**Re: Permit GR093ER – Part 4 Exploration Permit;
Application Amendment for the Tyrone Peak Project**

Freeport-McMoRan Tyrone Inc. (Tyrone) submitted a permit application request for the Tyrone Peak exploration project in a letter dated January 22, 2024. Attached is an amended permit application using the Part 4 Permit Application template from the Mining and Minerals Division's (MMD) website resources. The permit is being amended in response to additional studies, discussions with MMD, and requests or recommendations made during the field inspection that occurred on February 12, 2024.

**SUBPART 4
EXPLORATION
PERMIT APPLICATION**

Figure 2

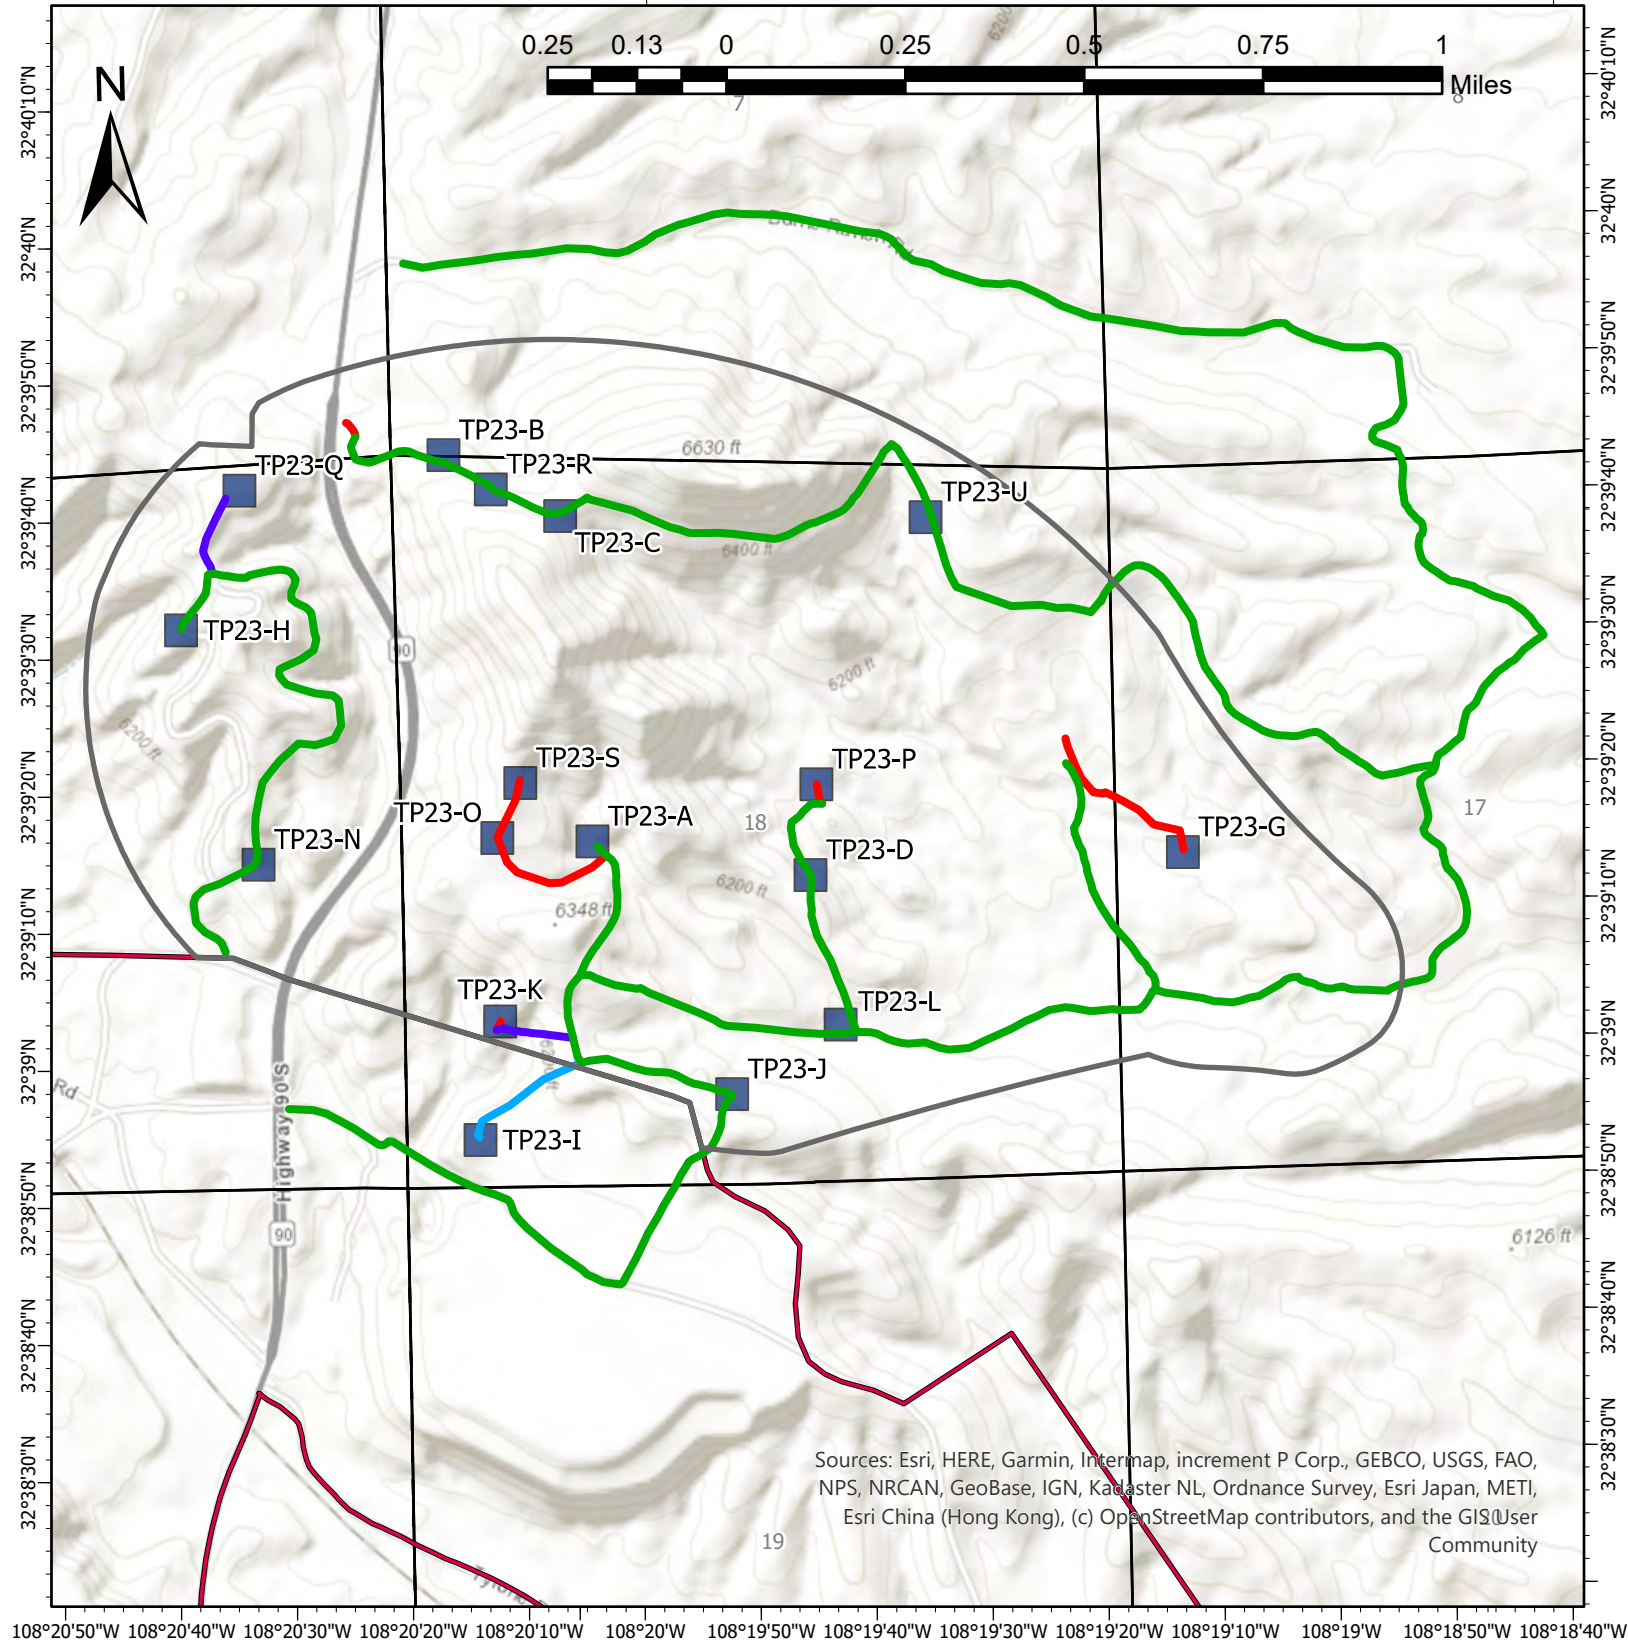
2. Removed Pads TP23-F and TP23-M from the plan due to confidential reasons communicated to MMD on August 1, 2024. These holes will be drilled from Pad TP23-G instead.

5. Corrected the error on the map in what was marked as “new road” vs “existing road” leading to Pad U from the east side of the project area via ranch roads.
6. Increased the proposed depth of the boreholes to 2,500ft targets which also changed the financial assurance (FA) needed for plugging and abandoning. Tyrone is also now proposing FA for only 4 open boreholes at any one time.
7. Included Pad I information upon request of MMD during the time of the inspection. This pad is located inside the GR010RE permit boundary (Tyrone Mine) and is regulated under that permit. It requires minimal disturbance as it will be overland operations only. It will also be seeded upon completion, but the FA needed for that activity is covered under the Tyrone permit’s maintenance allotments.
